49 CFR Part 571

[Docket No. NHTSA-2007-0052]

Federal Motor Vehicle Safety Standards; Platform Lifts for Motor Vehicles; Platform Lift Installations in Motor Vehicles

ACTION: Notice of proposed rulemaking (NPRM); grant in part, denial in part of petitions for rulemaking.

FIGURE 2

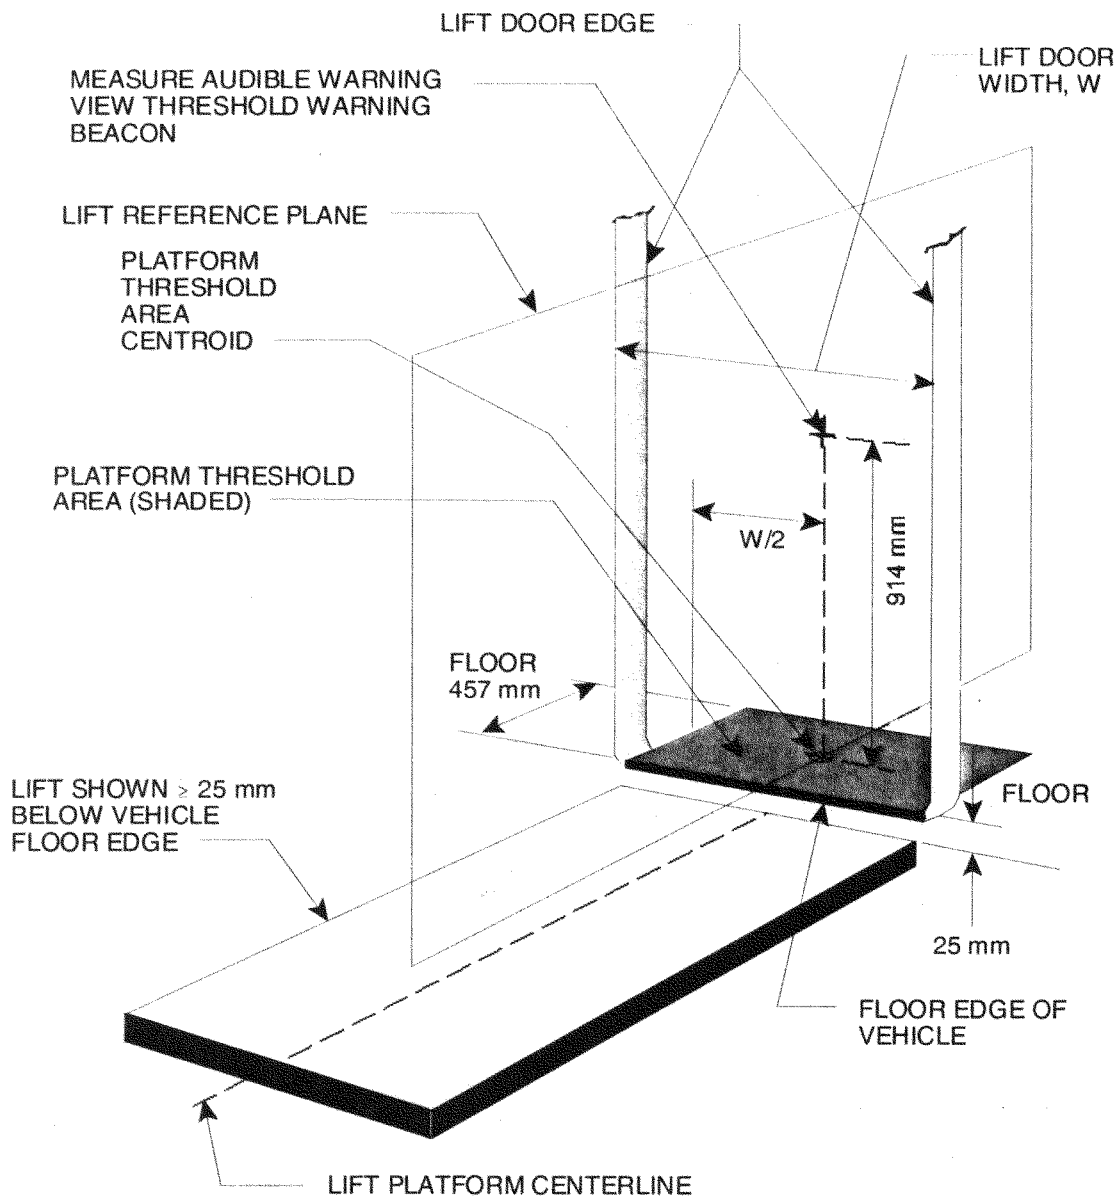
B. Correct Figure 2 in FMVSS No. 403 To Make it Consistent With the Threshold Beacon Warning Requirements in S6.1.6

It has come to NHTSA’s attention that a dimension in Figure 2 is incorrect. The height of the measurement point from which the intensity of the threshold audible warning is measured and the threshold warning beacon must be visible is identified as 919 mm. Because S6.1.6 provides that this measurement point is 914 mm (3 feet), we are proposing to replace Figure 2 with revised Figure 2, which shows a measurement point of 914 mm (3 feet), consistent with the requirements of S6.1.6.

S6.1.6 The intensity of the audible warning and visibility of the visual warning required by S6.1.2 and S6.1.3 is measured/observed at a location 914 mm (3 ft) above the center of the platform threshold area. (See Figure 2).
